## ORIGINATION FORM

Proposed Revisions to a Standard Plans Index  
(Please provide all information — Incomplete forms will be returned)

Index Number: 646-001  
Sheet Number (s): 1 of 1  
Index Title:  
Aluminum Post and Pedestal Mounted  
Pedestrian Detectors and Signals

POST MOUNTED

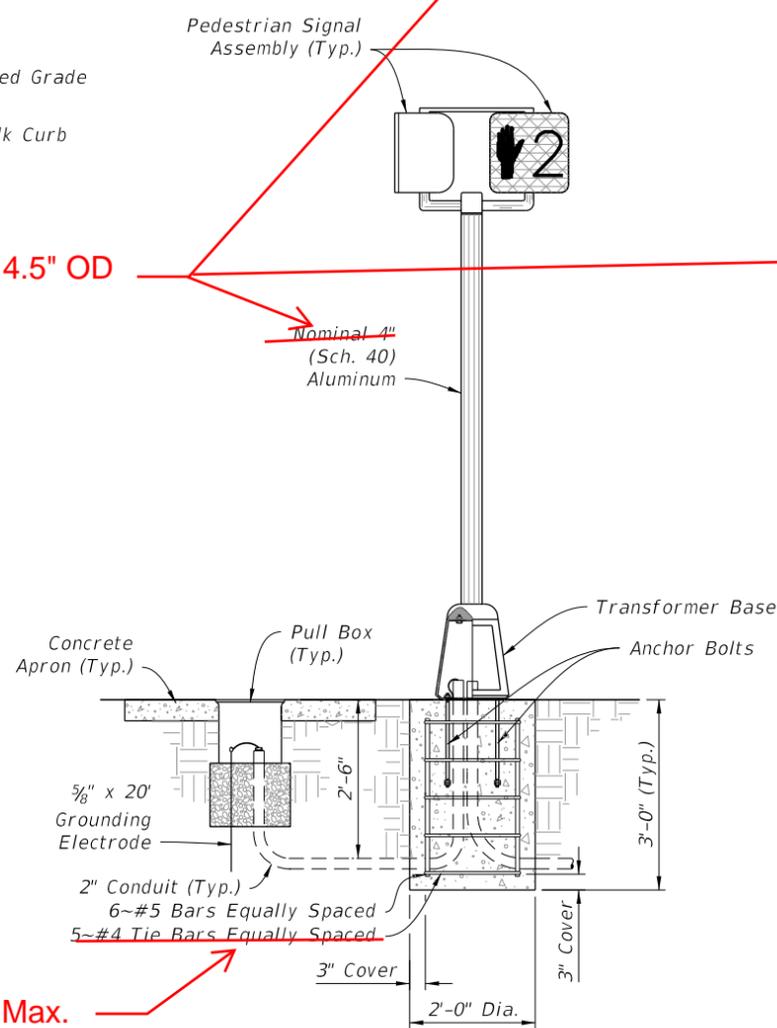
**CHANGED TO: #4 Stirrups Equally Spaced, 12" Max.**

ADJACENT TO SIDEWALK

PEDESTAL MOUNTED

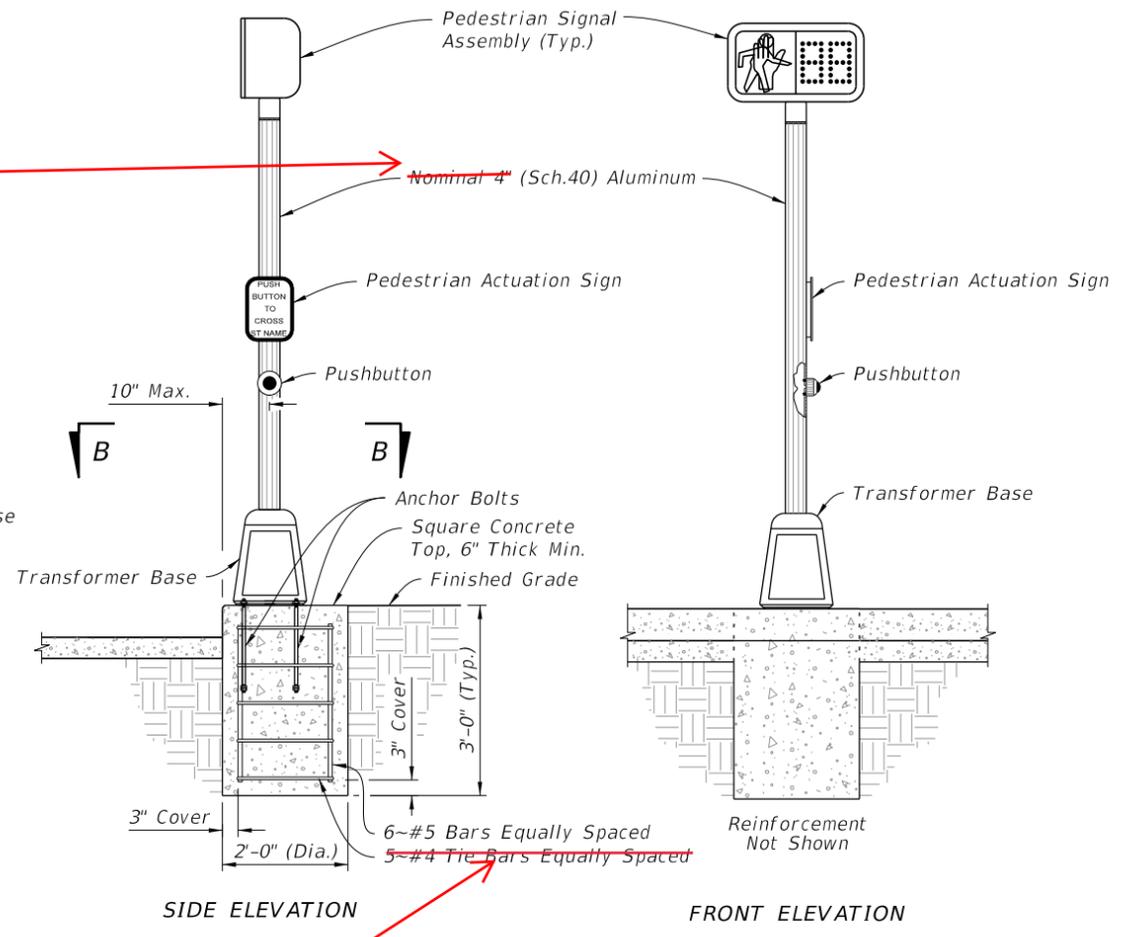
Updated the PEDESTAL MOUNTED detail - to show in the ADJACENT TO SIDEWALK detail "Tie Bars" callout as a #4 Stirrups equally spaced, with a 12" maximum spacing and change all references "4" Nominal Aluminum Pole" to "4.5" OD Aluminum Pole;

ADJACENT TO SIDEWALK

**CHANGED TO: #4 Stirrups Equally Spaced, 12" Max.**
